Access Compliance Report

Public Rights-of-Way

(Island Curb Cuts)

Intersection ID: 10013834	Main Street: IKEA_BV	Cross Street: N/A	Location: W
ADA ID: 7F11FDFFF482	Curb Cut Type: MedianRefuge2	Initial Pass/Fail: Fail	Overall Compliance: No
Codes/Mitigation Info/Possible Solution		Field Measurements/Component Compliance	
Severity Score: 1.25

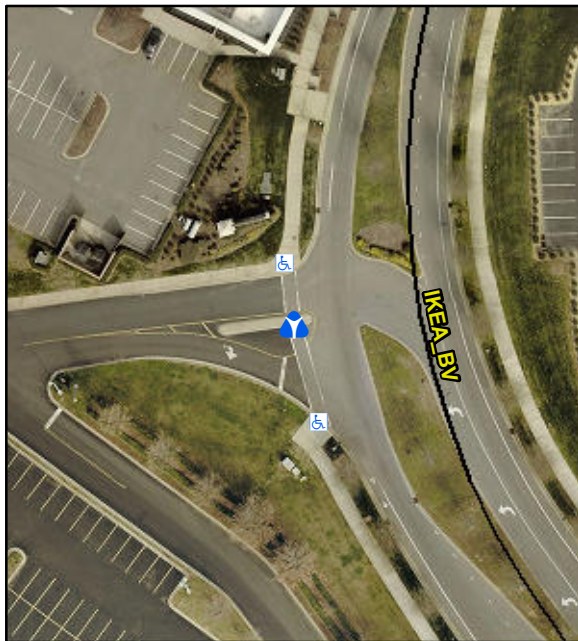
Compliance	Description	Data	Compliance	Description	Data
No	Refuge 1 Length (In)	35.5	N/A	Gutter 1 Ponding?	N/A
Yes	Refuge 1 Width (In)	78.5	N/A	Gutter 1 Lip Ht (In)	N/A
Yes	Refuge 1 Slope (%)	0.5	N/A	Gutter 1 Slope (%)	N/A
Yes	Refuge 1 X Slope (%)	2.3	N/A	Gutter 1 X Slope (%)	N/A
N/A	Painted X Walk1?	Yes	N/A	DWS 1 Provided?	N/A
N/A	X Walk 1 Direction	To N	N/A	DWS 1 Contrast?	N/A
N/A	X Walk 1 Width (In)	79.5	N/A	DWS 1 Length (In)	N/A
N/A	Road 1 Slope (%)	2.3	N/A	DWS 1 Full Width?	N/A
N/A	Road 1 X Slope (%)	1.7	N/A	DWS 1 Offset (In)	N/A
No	Refuge 2 Length (In)	35.5	N/A	Gutter 2 Ponding?	N/A
Yes	Refuge 2 Width (In)	78.5	N/A	Gutter 2 Lip Ht (In)	N/A
Yes	Refuge 2 Slope (%)	3.1	N/A	Gutter 2 Slope (%)	N/A
Yes	Refuge 2 X Slope (%)	1.4	N/A	Gutter 2 X Slope (%)	N/A
N/A	Painted X Walk2?	Yes	N/A	DWS 2 Provided?	N/A
N/A	X Walk 2 Direction	To S	N/A	DWS 2 Contrast?	N/A
N/A	X Walk 2 Width (In)	77.0	N/A	DWS 2 Length (In)	N/A

Remove & Replace Entire Refuge.
